CITY OF ALBUQUERQUE

RE: Sunset Farms / Puesta Del Sol Subdivision
336 Luis Sanchez Place SW
Request for Permanent C.O. – Not Accepted
Engineer's Stamp Date: 06/23/17
Engineer's Certification Dated: 01/04/18
Hydrology File: K12D025

SANCHEZ/GALLEGOS - GRADING & DRAINAGE PLAN

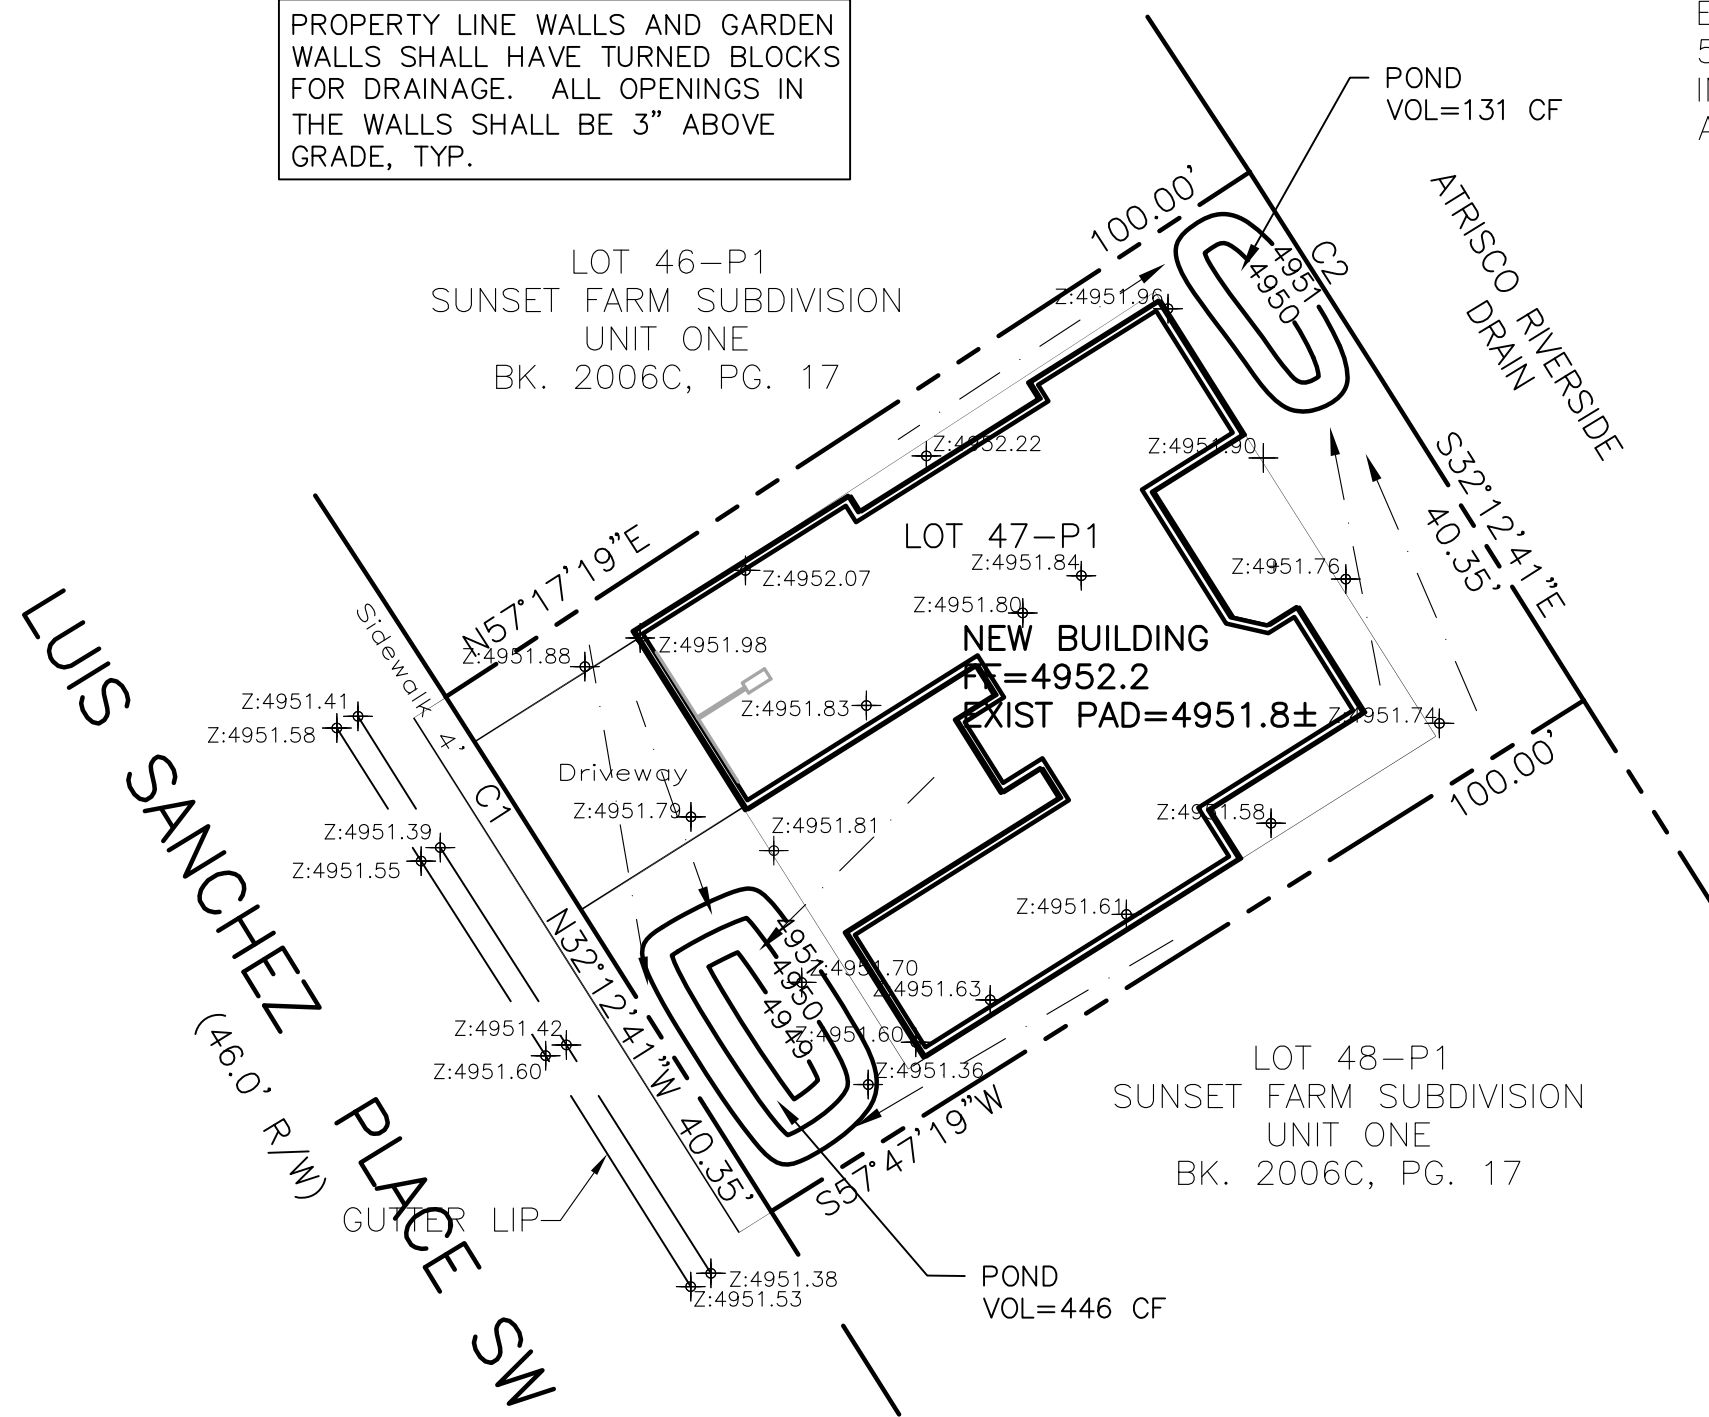
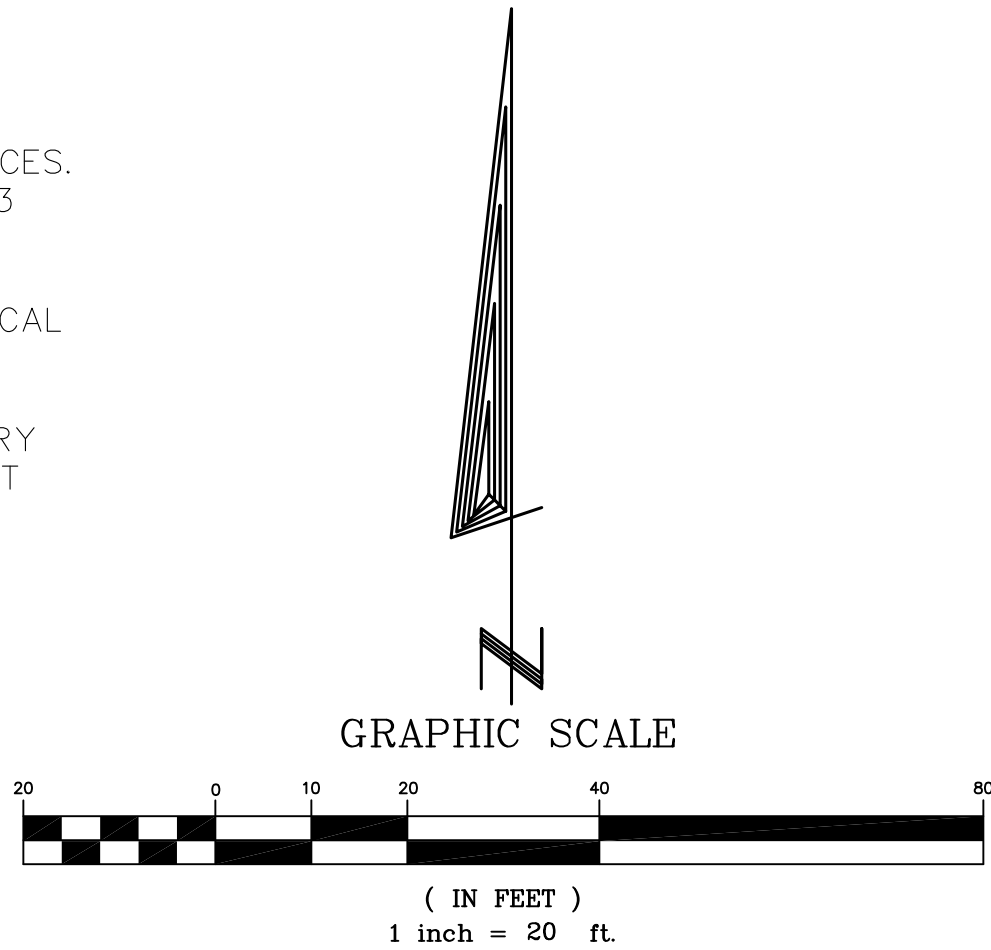
1. The required pond in the rear does not exist (see photo below). Either, this pond needs to be built, or the pond in the front needs to pick up the difference of what was designed and the required 509CF.
